# Review of ORAUT-OTIB-0081, Revision 04, “Internal Coworker Dosimetry Data for the Savannah River Site ”

Bob Barton, Ron Buchanan,  
Harry Chmelynski, Rose Gogliotti,  
Joyce Lipzstein  
SC&A, Inc.

Savannah River Site/SEC Issues Work Groups Meeting  
December 5–6, 2019

## Coworker Data Adequacy – Bioassay Variability

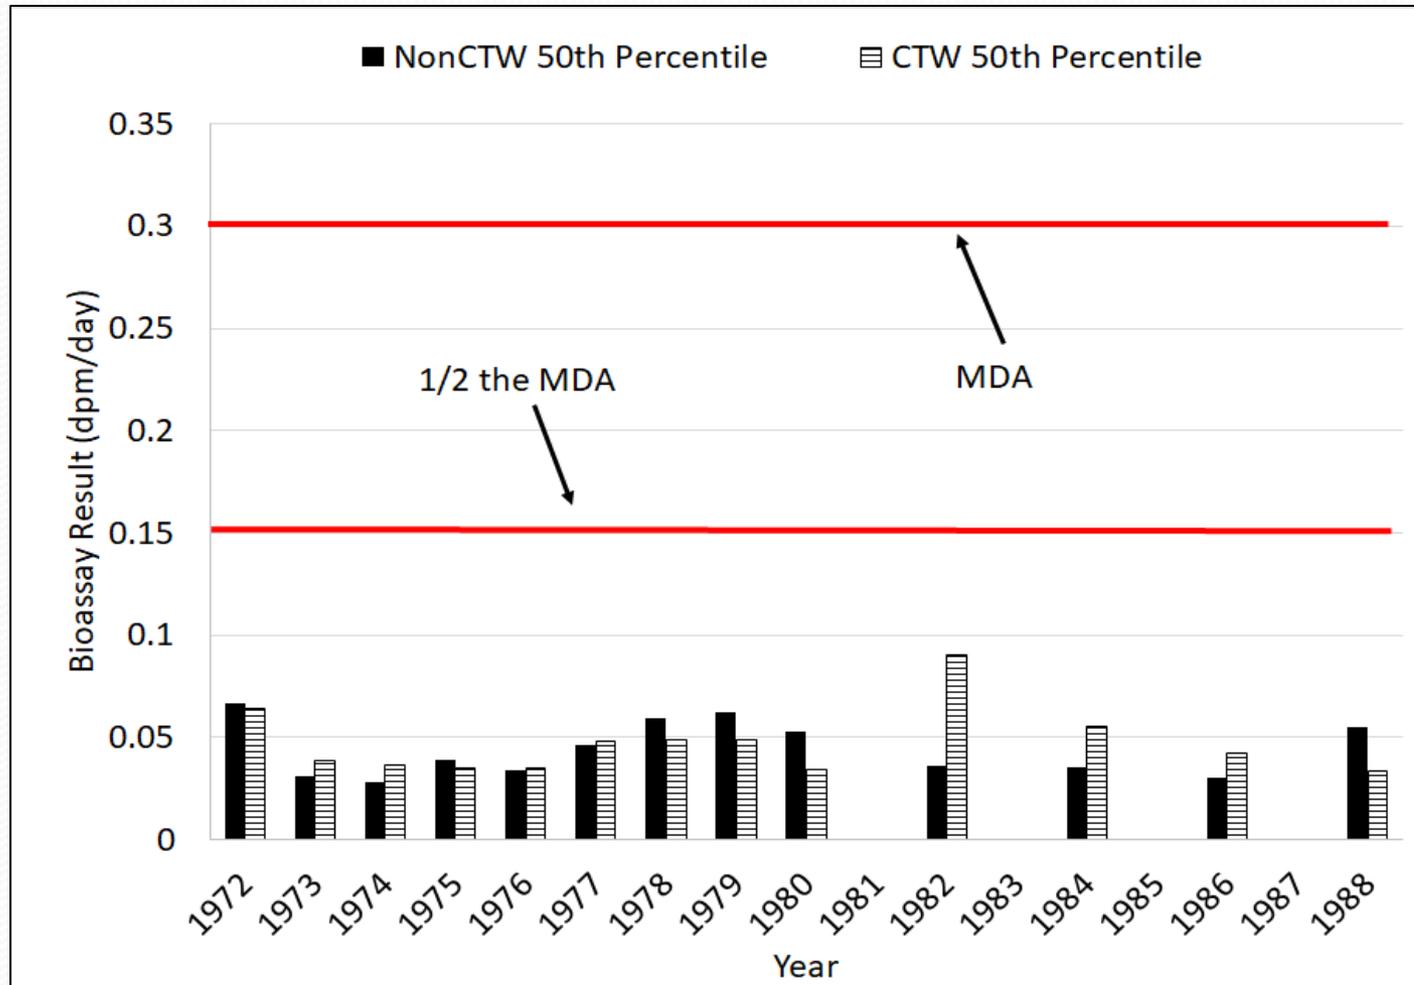
- SC&A has expressed concern about observed variability in transuranic (Am/Cm/Cf) measurements of the same bioassay sample in previous SRS reviews and work group discussions.
- **Key Question:** Is the measurement technique sufficiently accurate to reflect the exposure potential it is intended to quantify?
- **OTIB-0081 Concluded:**
  - Small percentage of the identified samples that are unaffected by chelation showed high variability (4 of 52)
  - “aliquot variability has an insignificant effect on the overall results”

# Coworker Data Completeness – Percentage of Additional Claimant Data Available

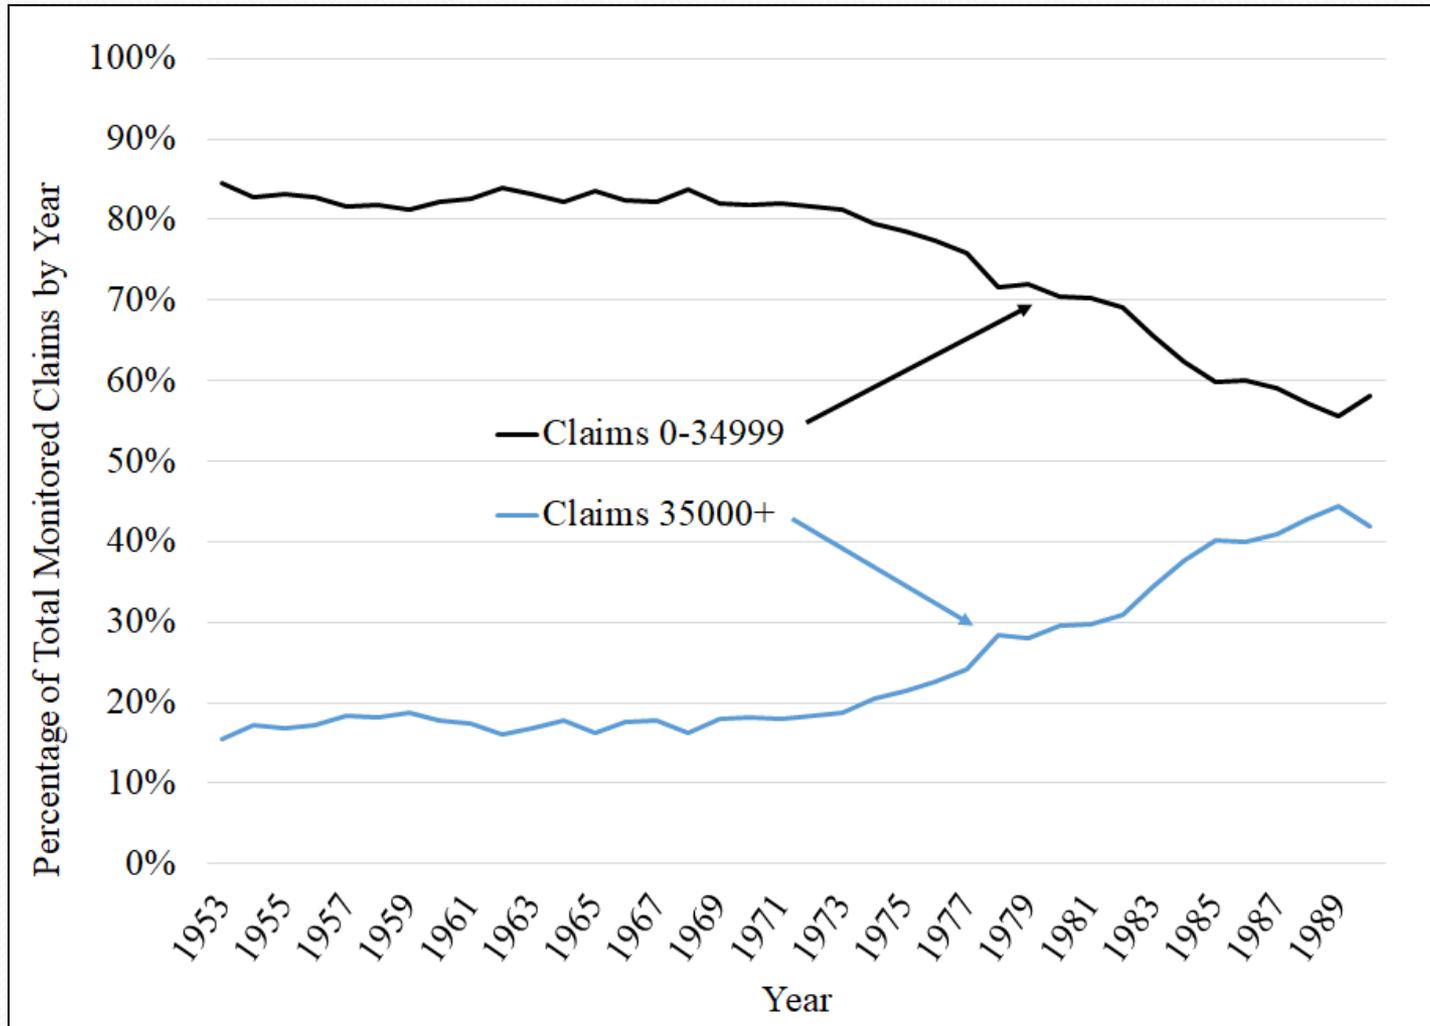
**Finding 4:** The coworker analysis uses the internal monitoring for claimants for which data were available to NIOSH in approximately August 2011 (~4,000 claims). Since that time, approximately 2,000 additional claims have been submitted that could be used to augment the coworker dataset. Inclusion of these data would be especially important for the two contaminants that required a combination of multiple years for analysis due to lack of a sufficient number of data points (uranium and cesium).

## Coworker Data Completeness – Comparison of Reported Bioassay Totals to Bioassay Available for Analysis

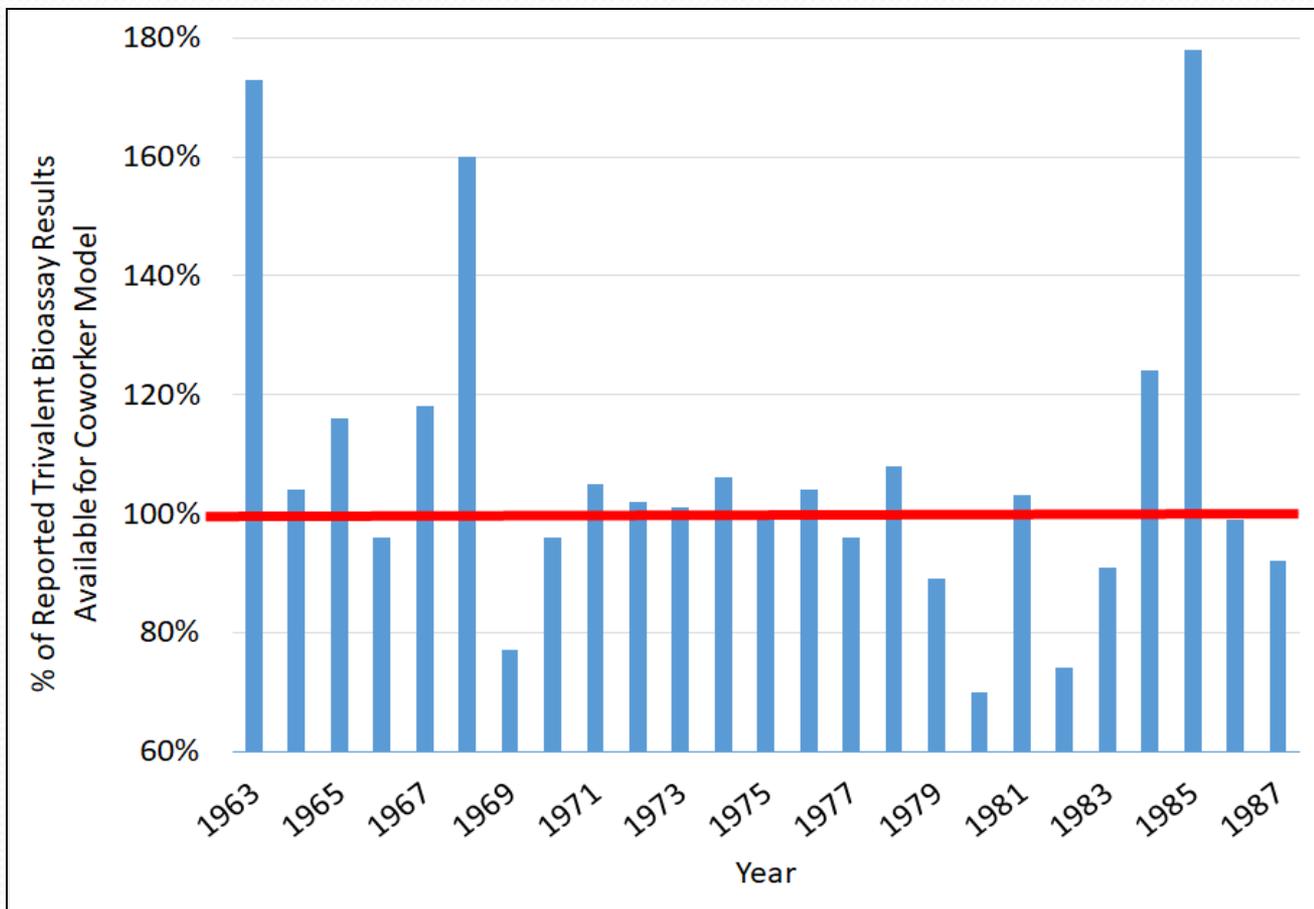
**Observation 3:** Available trivalent logbook data show notable differences with the number of reported samples taken in 1980 and 1982. These years, and any changes in operations, are not discussed specifically in OTIB-0081. However, it is noted that a future NIOSH report on americium exposure potential at SRS is pending that may address the apparent gaps in the data.

- **UPDATE:** NIOSH has since released ORAUT-RPRT-0091, “Evaluation of Savannah River Site Americium-241 Source Terms Between 1971 and 1999 Using Bioassay Frequency Tables.” However, the report does not specifically address the issue of missing Am/Cm/Cf bioassay results during the years identified.
